PLANNING COMMISSION
Regular Meeting
Monday, November 23, 2020
6:00 PM
Virtual Meeting

TO: Planning Commission
FROM: JAC ZADER, ASSISTANT DIRECTOR COMMUNITY DEVELOPMENT
DATE: November 23, 2020
SUBJECT: Mequon Medical. The applicant is seeking building and site plan and specimen tree removal approval for a 29,500 sq. ft. +/- outpatient medical clinic for the property located at the northwest corner of Highland Road and Port Washington Road.

PROJECT:
ASCENSION MEQUON CLINIC
CITY OF MEQUON, WISCONSIN

LSP1.4

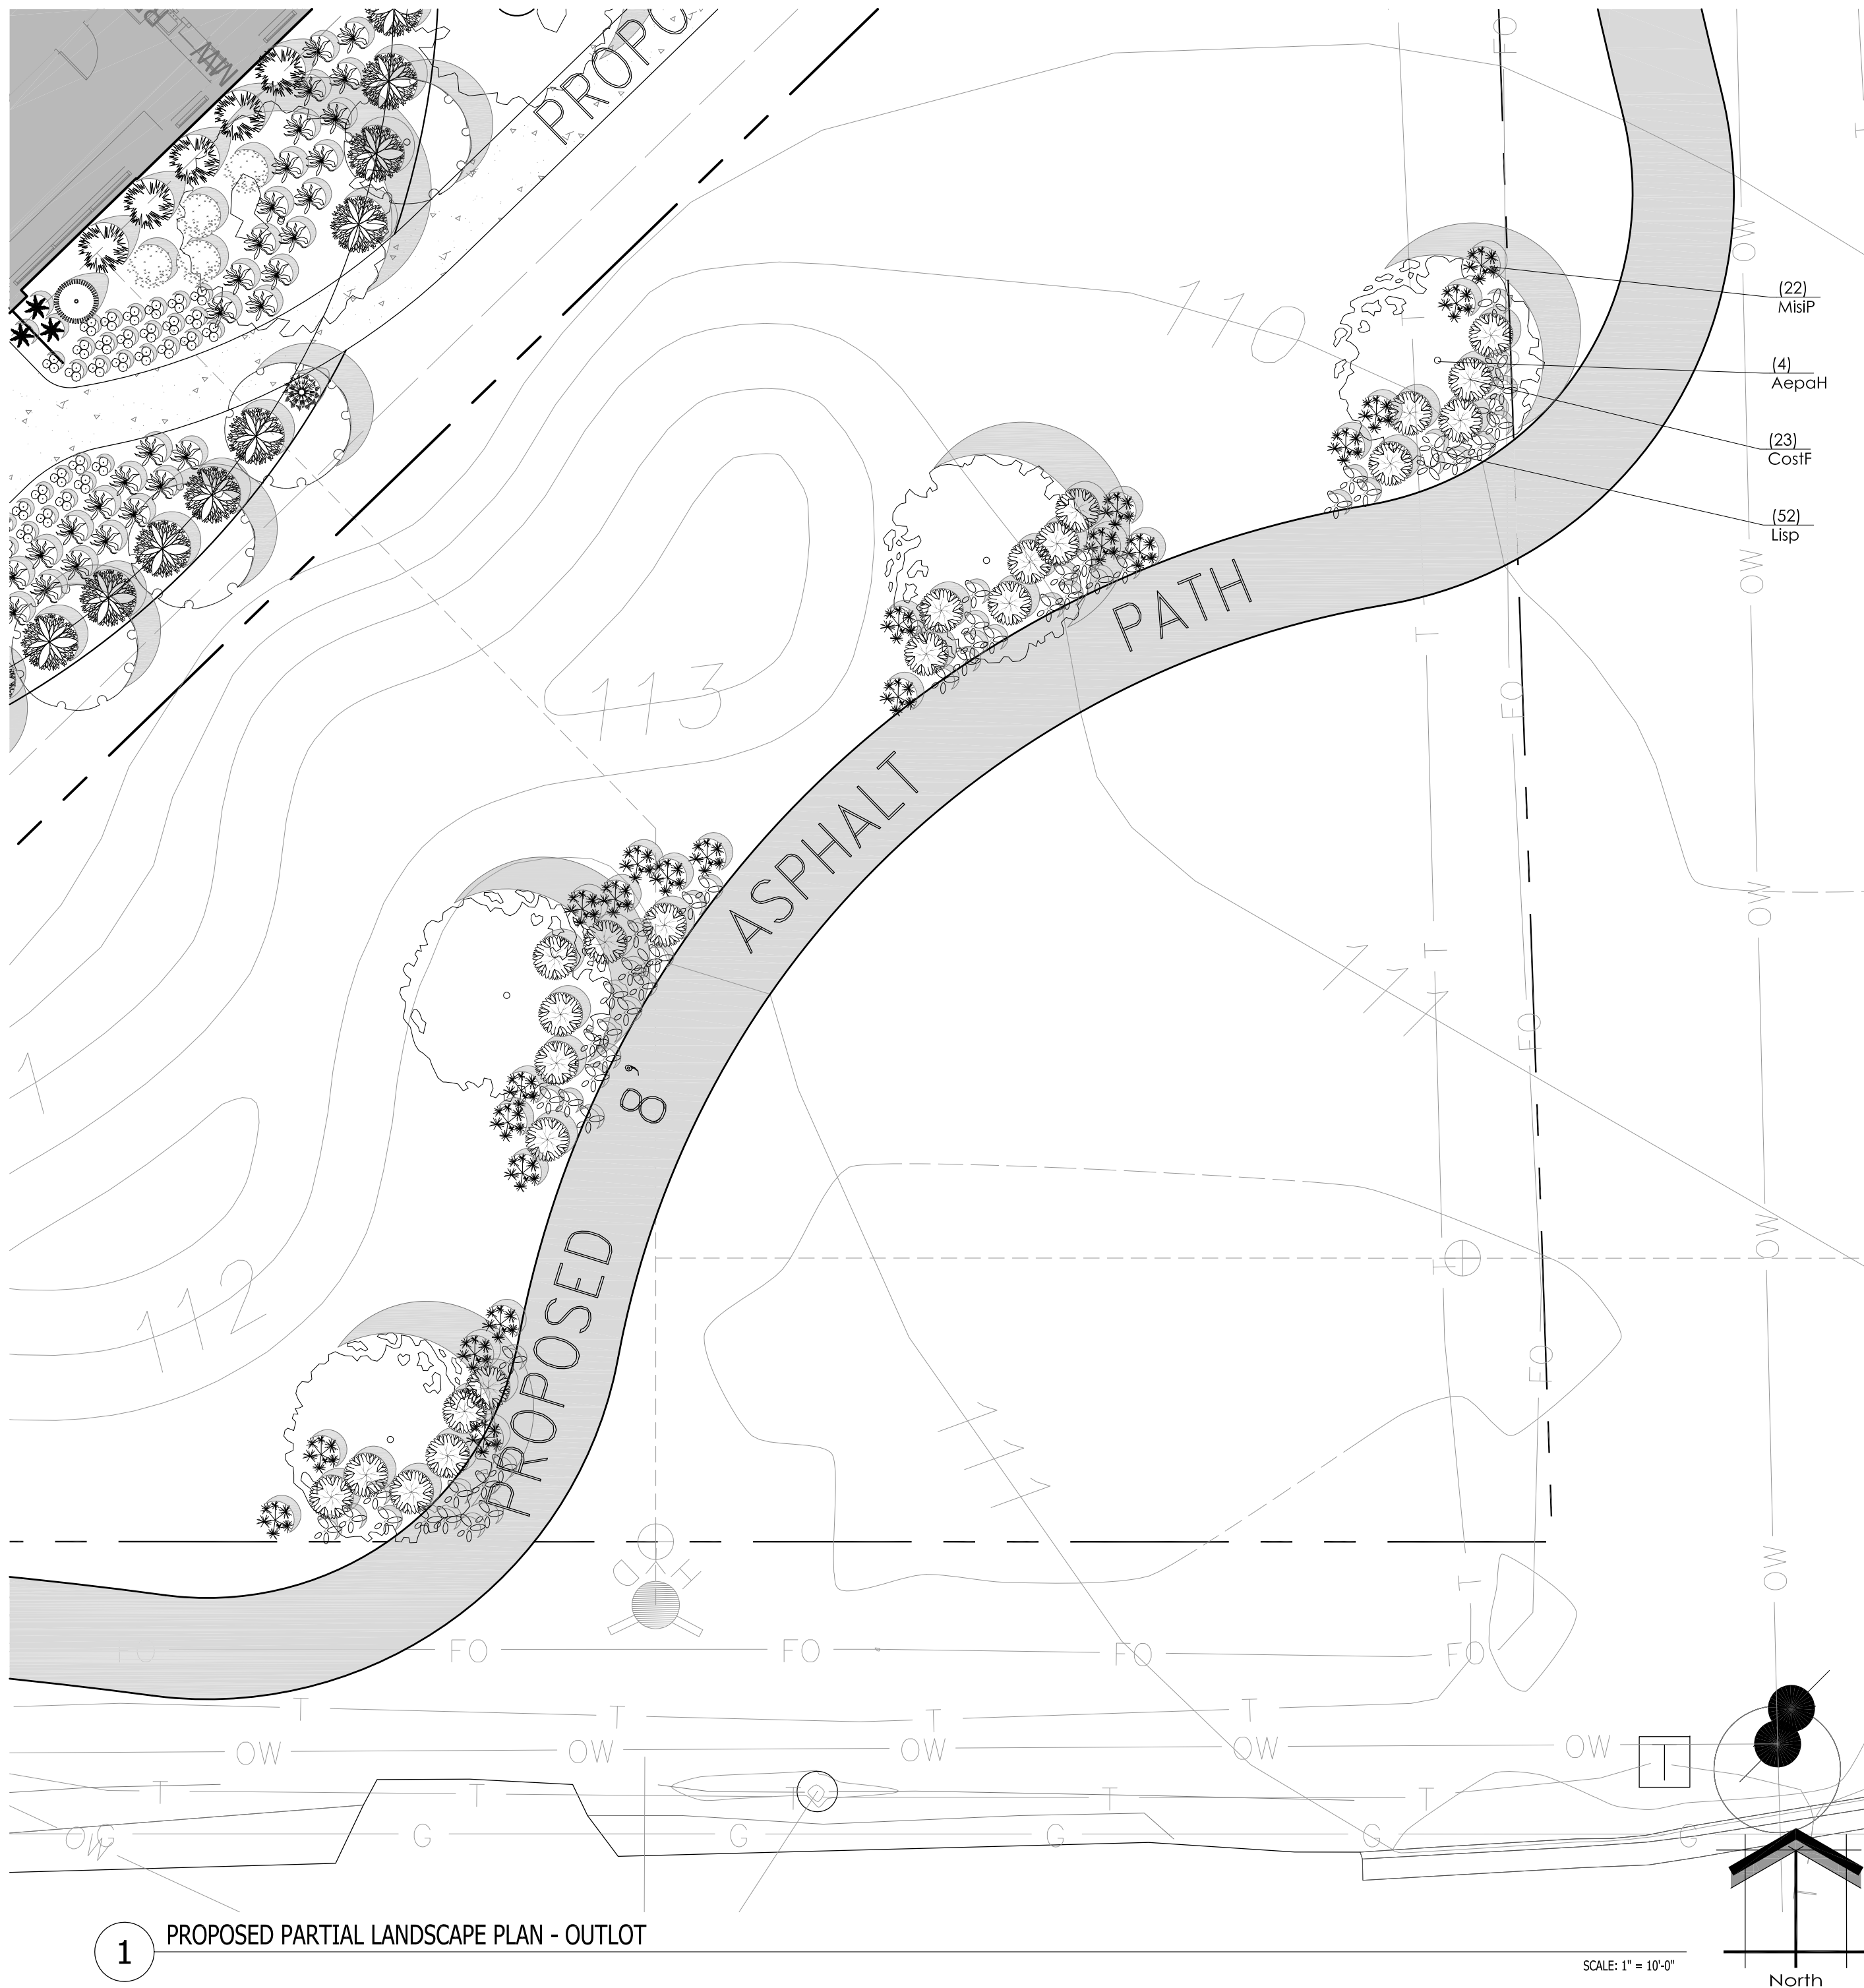
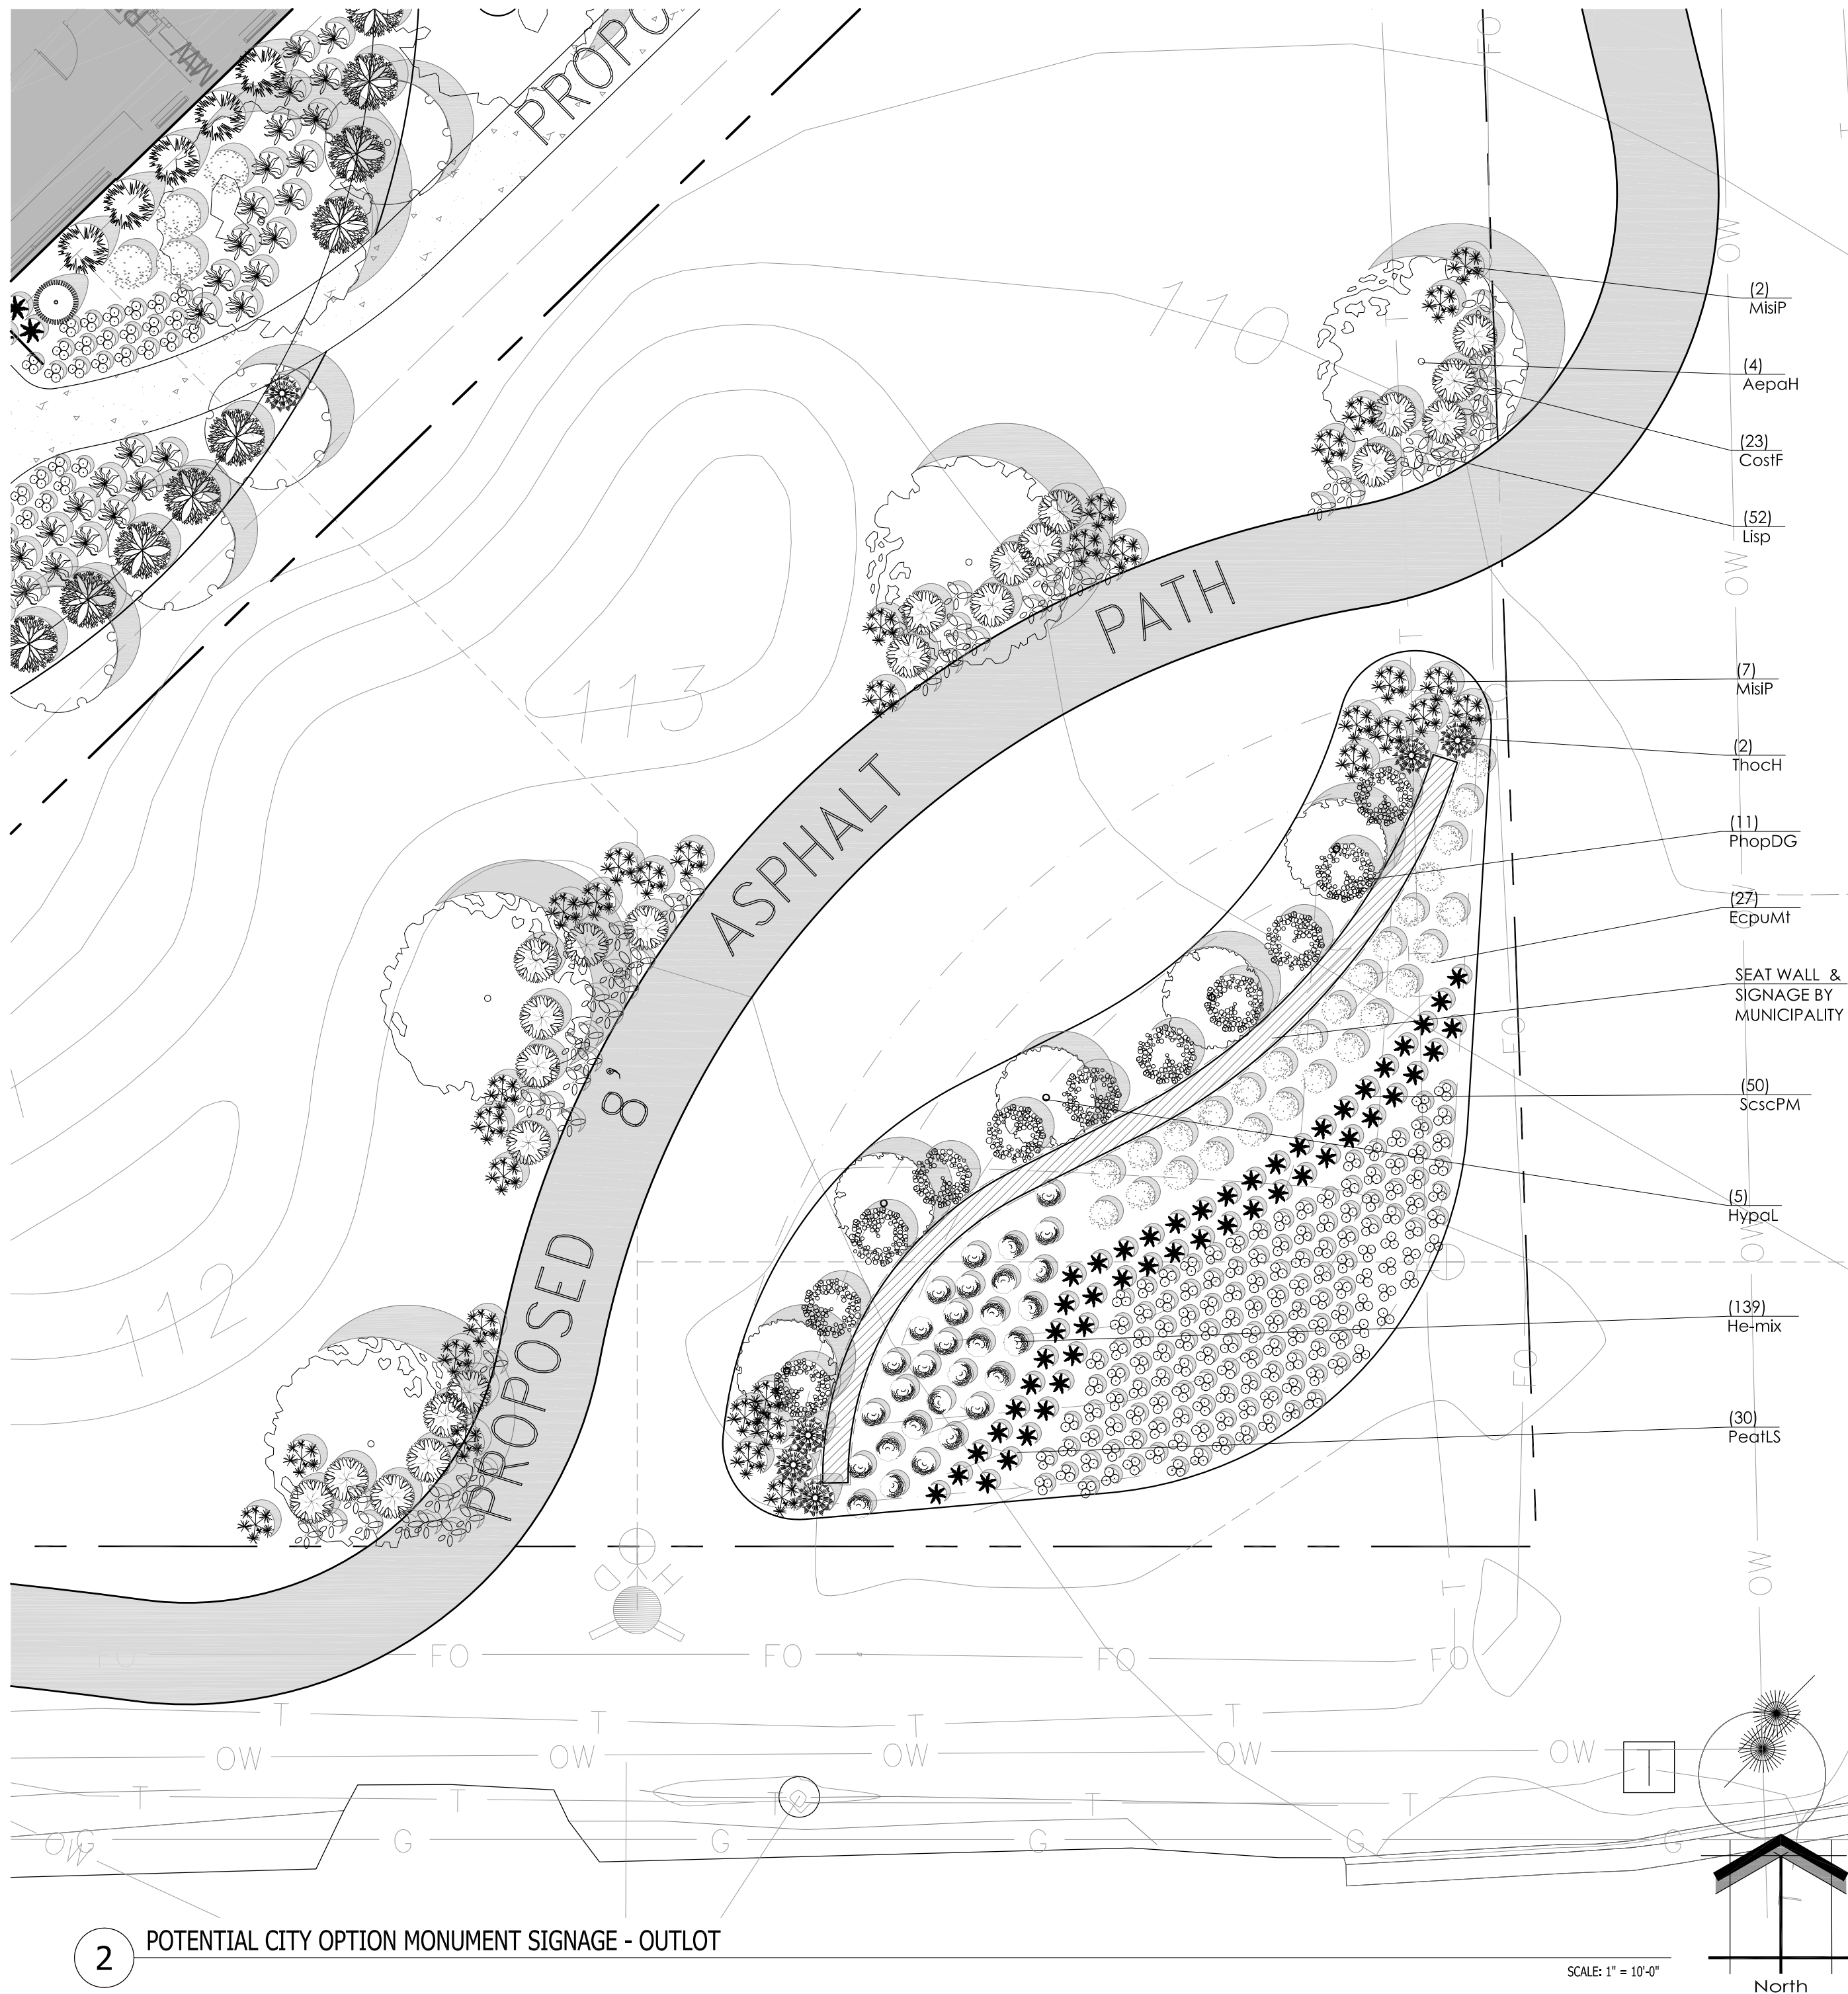
- Provided on sheet LSP1.4, the plan notes: "Seat Wall & Signage by Municipality". I have no notes from City Planning Office to support the noted Public/Private agreement. - <To be confirmed by City Staff.>
